złączka węża Makita 413490-2 (459223-1)

DC179

Title	Change of Arm set, Joint, Hose connector, Dust nozzle Elimination of O ring 20, O ring 23 Addition of Rivet 7
Model	DSL800, XLS01
Country	All countries
Description	To improve the dust collecting efficiency; • Arm set, Joint, Hose connector and Dust nozzle will be changed. • O ring 20 and O ring 23 will be eliminated. • Rivet 7 will be added.

[1] Arm set (183L76-5)

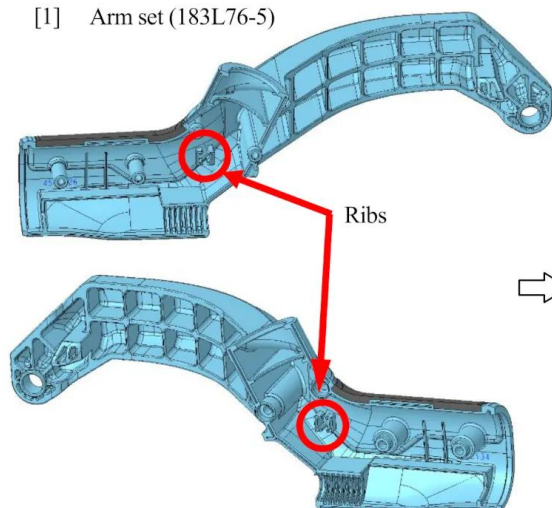
Arm set (183T15-3)

[2] Joint (459222-3)

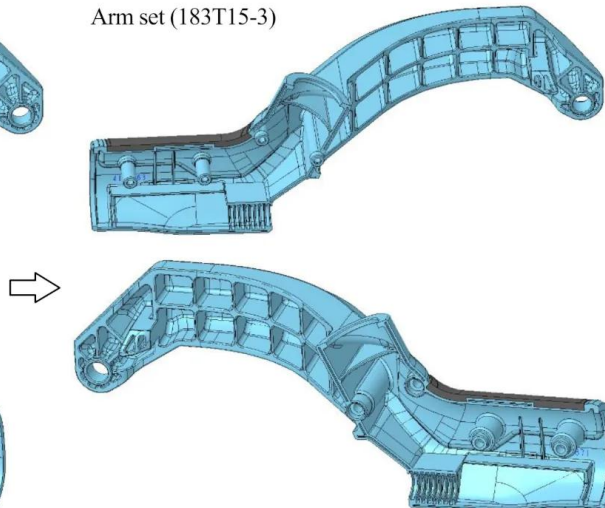
Joint (422617-3)

[3] Hose connector (459223-1)

Hose connector (413490-2)

- [4] Elimination of O ring 20 attached to the current Joint
- [5] Elimination of O ring 23 attached to the current Joint

[6] Dust nozzle (459234-6)

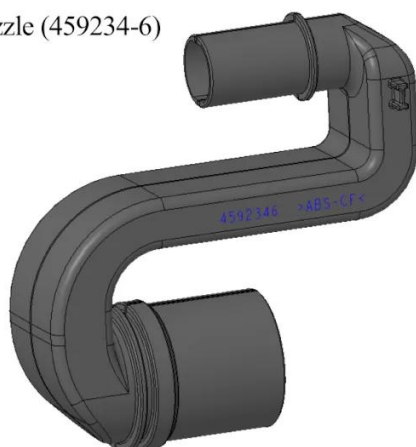
Dust nozzle assy (127672-7)

[7] Addition of Rivet 7 (412987-8)

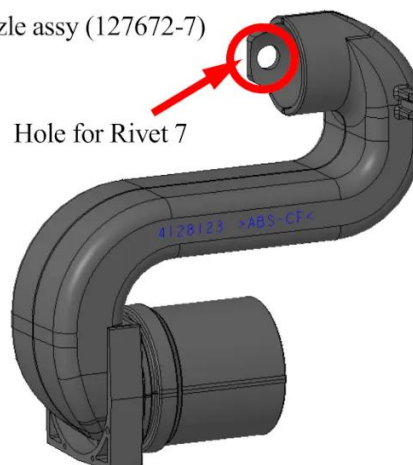
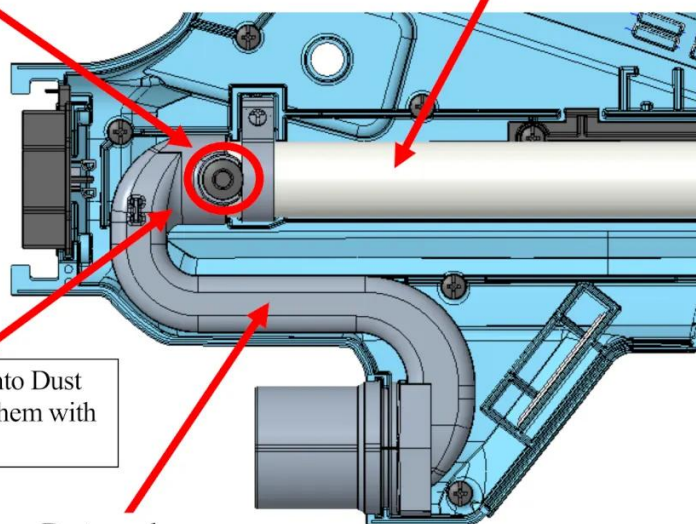
Insert Pipe B complete into Dust nozzle assy, then fasten them with Rivet 7 (412987-8).
